**MONTGOMERY COUNTY HISTORIC PRESERVATION COMMISSION**  
**STAFF REPORT**

**Address:** 10304 Montgomery Avenue, Kensington      **Meeting Date:** 3/20/2024  
**Resource:** Primary Resource      **Report Date:** 3/13/2024  
**Kensington Historic District**  
**Applicant:** Jeff and Gloria Capron      **Public Notice:** 3/6/2024  
(Luke Olson, Architect)  
**Review:** Historic Area Work Permit      **Tax Credit:** Partial  
**Permit Number:** 1060765      **Staff:** Chris Berger  
**PROPOSAL:** Fenestration alteration, new additions, hardscape alterations, construction of new detached garage.

Staff recommends that the Historic Preservation Commission (HPC) **approve with five conditions** the HAWP application with final review and approval of all details delegated to staff:

**2** PROPOSED RIGHT SIDE ELEVATION  
SCALE: 1/8"=1'-0"

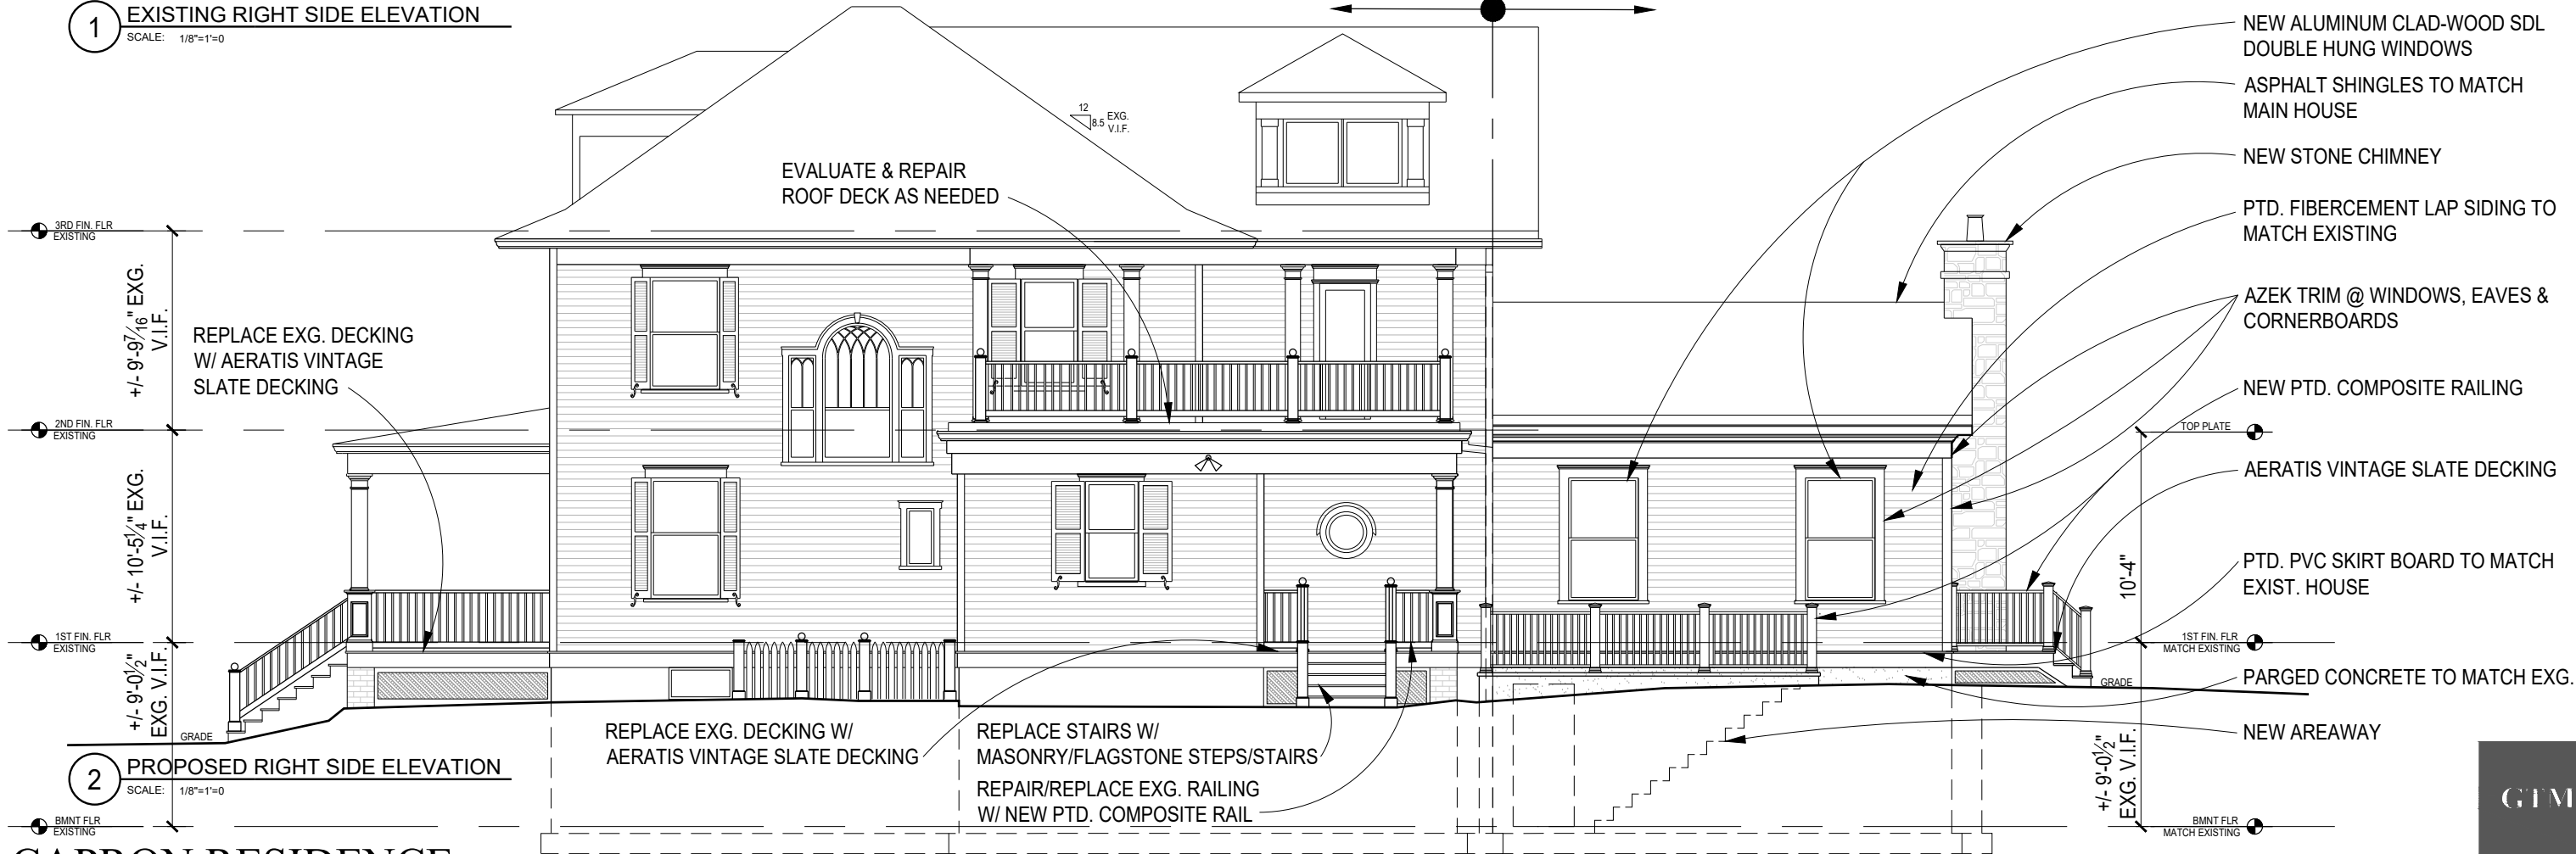
Evaluating the proposal under Chapter 24A, Staff finds the proposal to change the wood porch decking on the original porch to a non-wood material is an inappropriate substitute material and recommends the HPC deny the work item under 24A-8(a). Staff finds that the proposed porch replacement will substantially alter the exterior features of a historic resource, contrary to 24A-8(b)(1). Staff additionally finds the proposed material is not a compatible substitute for wood decking for original front porches in the Kensington Historic District and does not meet 24A-8(b)(2). Staff does not find the proposed work will provide additional protection for the site under 24A-8(b)(3), nor that the existing condition is unsafe or a health hazard as generally understood under 24A-8(b)(4). Staff finds that property owners will not be deprived of reasonable use or suffer “undue hardship” of their property under 24A-8(b)(5) if the work is not approved. Staff does not find that in applying a balancing test, the public is better served by granting

Staff supports the Hampton composite railing and brick and flagstone steps for the right-side porch. The side porch was constructed in the 1980s, so per Chapter 24A-8(d) the HPC is to be lenient in its judgement of the plans unless such plans would seriously impair the historic or architectural value of the surrounding historic resources or impair the character of the district. Staff finds this would not be the case with the proposed changes. The applicant’s architect noted the existing front- and right-side porches are on brick piers, so the proposed materials match those already found on the historic resource. Staff seeks a condition that the applicant provide a detail for the replacement side porch. The proposed replacement materials on the side porch meet both Kensington’s Master Plan *Amendment* and *Vision*. In accordance with Chapter 24A-8(b), the proposal will not substantially alter the exterior features of an historic resource within an historic district, and the work is compatible in character with the historic district where synthetic materials on rear additions are common. It also conforms with the *Standards*, because the historic character of the property will be retained and preserved; the new enclosure will not destroy the historic materials that characterize a property and the new will be differentiated from the old; and the form and integrity of the property will be unimpaired if the synthetic porch materials are removed in the future.
